CITY OF BLOOMINGTON

PLAN COMMISSION

**February 5, 2018 @ 5:30 p.m.
COUNCIL CHAMBERS
#115 CITY HALL**

**BLOOMINGTON PLAN COMMISSION
STAFF REPORT
Location: 215 S. Walnut Street**

Lot Type and Yard Classification

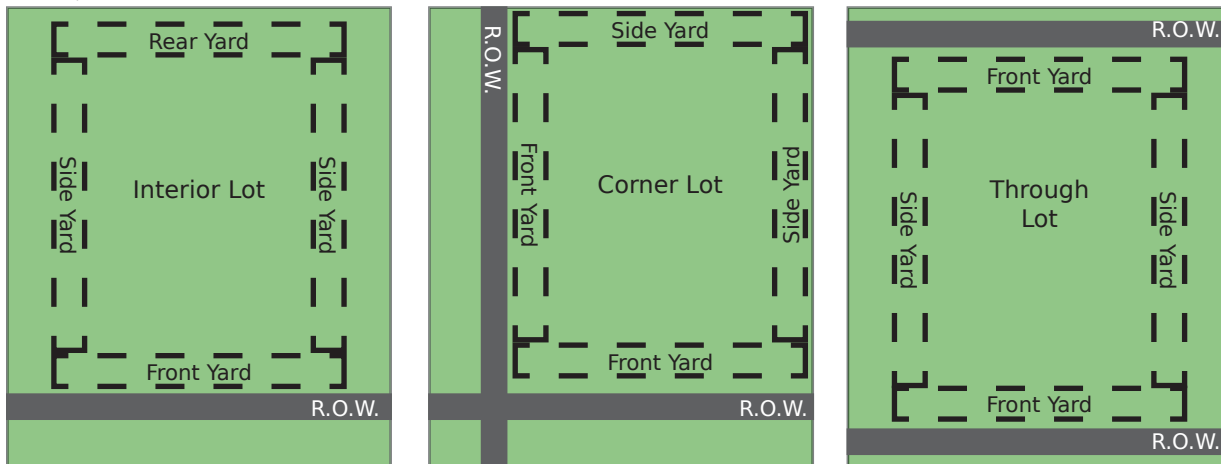
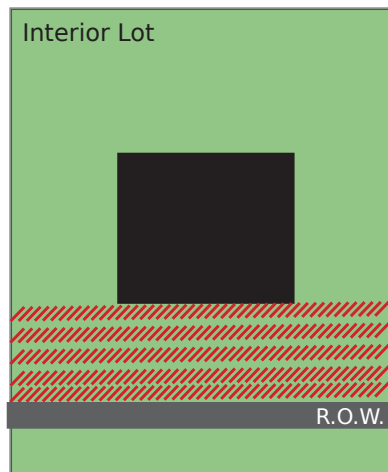
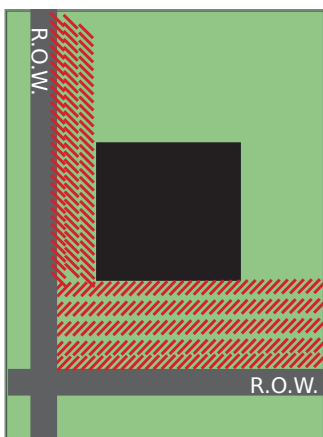
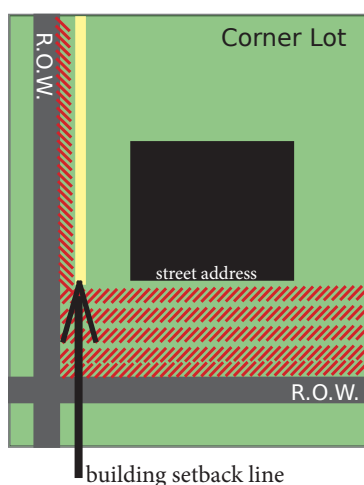
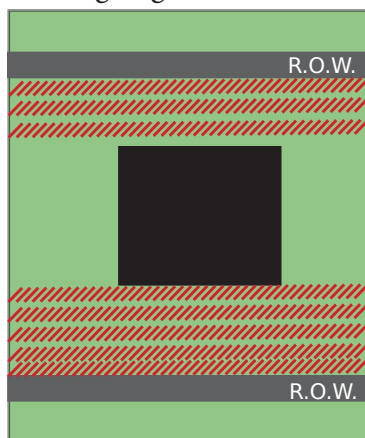
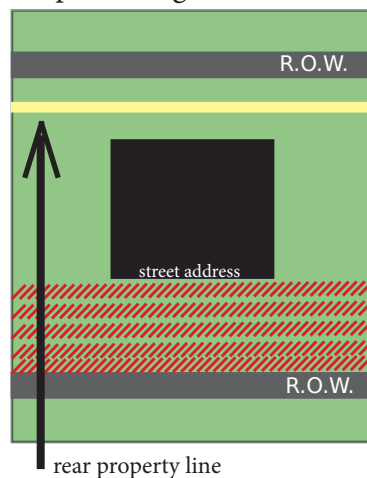
The regulations for interior lots will remain the same. The proposed amendment would make a distinction on corner lots and through lots between the primary front, where people typically enter their house, and the secondary front, the non-addressed side which functions as a side yard, but is still along a public street. The existing regulations for the primary front yard would remain the same.

For corner lots, on the secondary front, the non-addressed portion of the lot, fences up to eight (8) feet in height would be allowed up to the building setback line or the build-to-line, whichever applies. This would ensure the fences maintain a distance from the sidewalk and adjacent street while still providing the ability to place a fence in a functioning side yard. Fences in the red area can not exceed 4 feet in height.

For the secondary front on through lots, the setback of fences up to eight (8) feet in height will be determined by the classification of the adjacent road. When the frontage is adjacent to a neighborhood street or secondary collector street, fences taller than four (4) feet in height shall meet the building setback. When the frontage is adjacent to a primary collector street or arterial street, fences exceeding four (4) feet shall be located at least ten (10) feet from the property line. Fences in the red area can not exceed 4 feet in height.

SOUTH ELEVATION (KIRKWOOD)

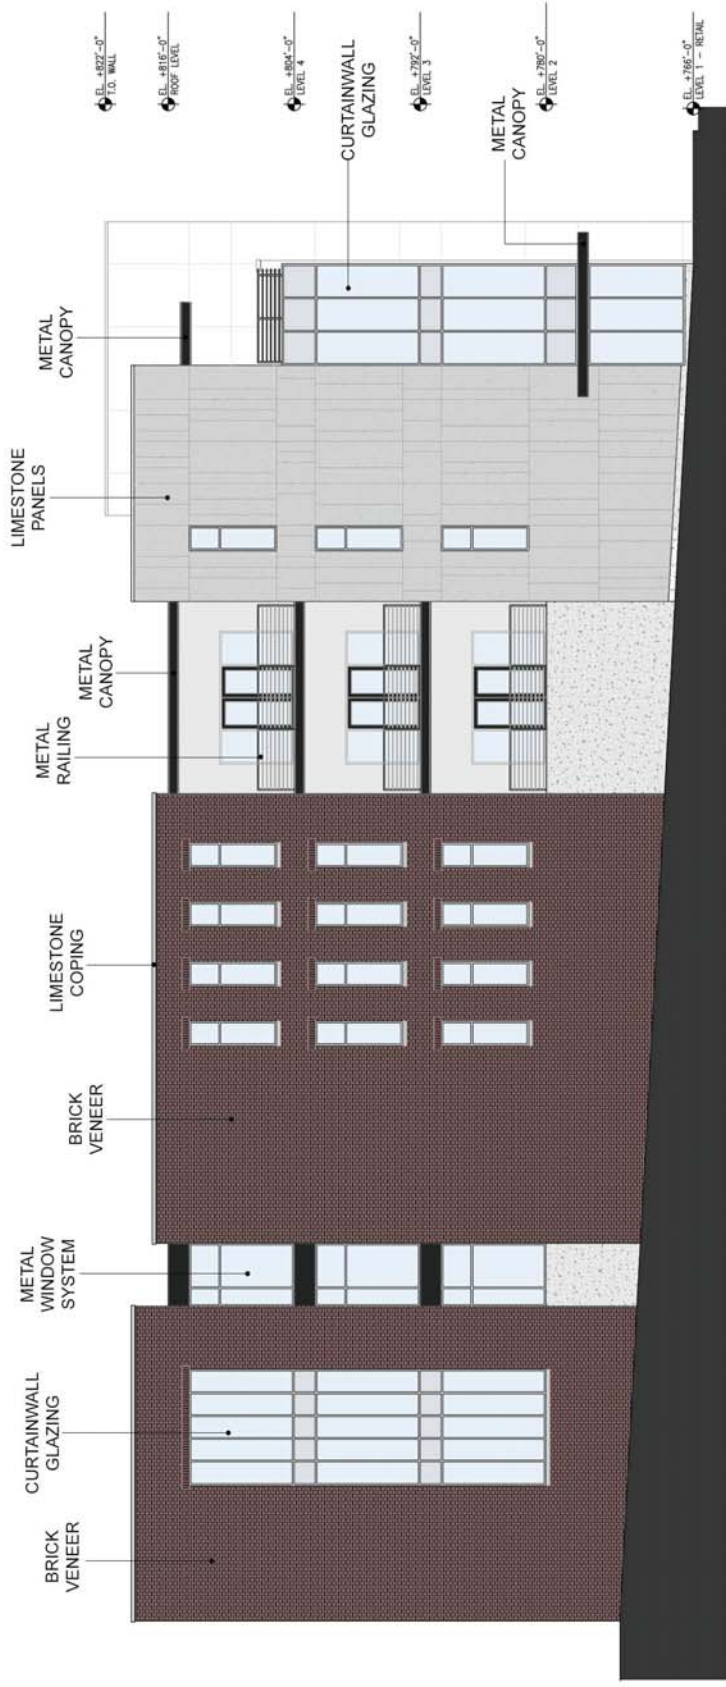
5. The additional brick areas added to the Kirkwood Elevation help by reducing the amount of curtainwall area above the 1st floor level. The brick elements on this elevation were further modified by lowering the top of the brick by one floor. The additional brick has been added at the 2nd and 3rd floors with the new top of the wall now terminating just below the 4th floor line.

6. Some areas of the new brick are now punctuated by window openings which help by imparting a better scale to the elevation.
7. In the updated drawings, two of the larger window openings on the Kirkwood Elevation have limestone surrounds while the remaining new openings have limestone sills, adding detail and interest. These new openings are also tall and narrow, providing additional variations to the opening proportions.

8. A metal cap has been added to the limestone walls. We would encourage the Petitioner to consider terminating the limestone walls with a limestone cap if possible.
